# Bridge Technical Committee – **Minutes** Wisconsin DOT, Industry, and Partners

Wednesday July 19<sup>th</sup>, 2017

**TYPICAL SECTION THRU BOX CULVERT**

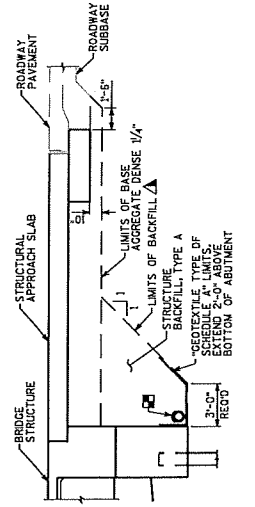
1. **Structural Backfill for Box Culverts (Matt Grove, Bill Oliva, & James Luebke).** Matt raised a concern about excavation limits and structural backfill on box culverts in recent letting. This will be a discussion on what the intent and standards reflect. [Open discussion on the Bridge Manual Standard 9.01 and Structural Backfill and excavation limits.](#) This was a lively discussion without agreement between industry and the department.

The Department stance is that we are specifying where we want the structural backfill placed (required minimum amount) and that we are not indicating the limits of excavation for construction. We believe the limits of construction may vary by means and method. We understand that the limit of excavation will be different than the minimum limit for structural backfill.

Matt Grove indicated he would prefer to see the old detail (1:1 Slope). The old detail showed a sloping limit that extended beyond the minimal limit the department wanted for structural backfill.

The big question is do we show a slope beyond the minimal required limit of backfill.

BOS Staff will reexamine this issue to determine if there is anything else they want to add or revise. More discussion at the November BTC Meeting.
